Item Name: Fwd Crosstube - Extended Height 39"

DART AEROSPACE LTD		Work Order:	130288
Description: Crosstube High-High Fwd		Part Number:	D205-596-101
Inspection Dwg: D205-596-101 Rev: B		Page 1 of 1

DRAWING NO. D205-596-101	TITLE CROSSTUBE ASS'Y, HI-HI FWD	REV. B	DART AEROSPACE LTD ENGINEERING ORDER		D.E.O. NO. D205-596-101-B-2	SHEET NO. SHEET 1 OF 1	SCALE NTS
DRAWN <i>MP</i>	CHECKED <i>A.P.</i>	MFG. APPR. <i>M</i>	APPROVED <i>MP</i>		DE APPR. <i>MP</i>		
DATE 13.11.11	DATE 13.11.19	DATE 13.11.19	DATE 13/11/21		DATE 13/11/21

DRAWING NO. D205-596-101	TITLE CROSSTUBE	REV. B	DART AEROSPACE LTD ENGINEERING ORDER		D.E.O. NO. D205-596-101-B-3	SHEET NO. SHEET 1 OF 1	SCALE NTS
DRAWN <i>q</i>	CHECKED <i>A.P.</i>	MFG. APPR. <i>A</i>	APPROVED <i>q</i>		DE APPR. <i>q</i>		
DATE 15.01.15	DATE 15.01.20	DATE 15.01.20	DATE 15.01.20		DATE 15.01.20

FIGURE 1 - SUPPORT INSTALLATION

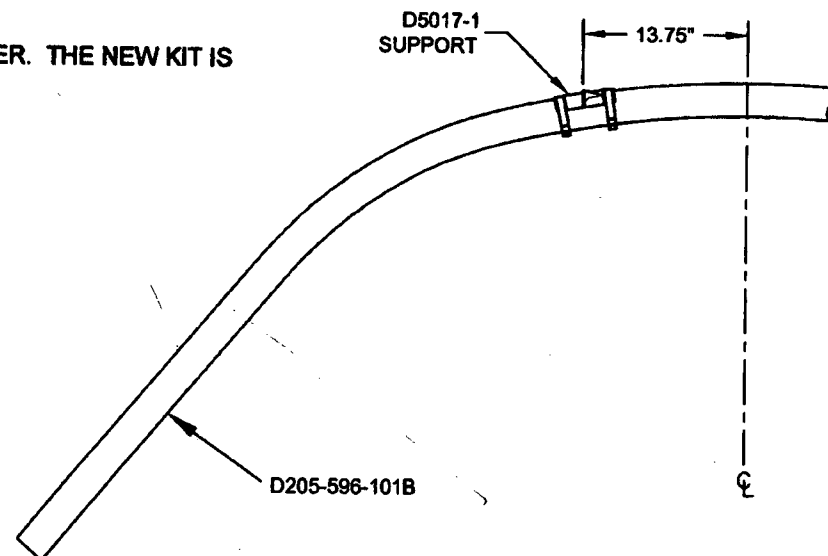
ADD THE FOLLOWING CROSSTUBE ASSEMBLY:

THE D205-596-101B CROSSTUBE HAS THE SAME PARTS LIST AS THE D205-596-101 CROSSTUBE EXCEPT AS FOLLOWS:

IS:

2	D5017-1	SUPPORT
---	---------	---------

WAS:

2	D2893-1	SUPPORT
---	---------	---------

INSTALL THE SUPPORTS AS SHOWN IN FIGURE 1 OF THIS ENGINEERING ORDER. THE NEW KIT IS OTHERWISE ASSEMBLED PER THE D205-596-101 CROSSTUBE.
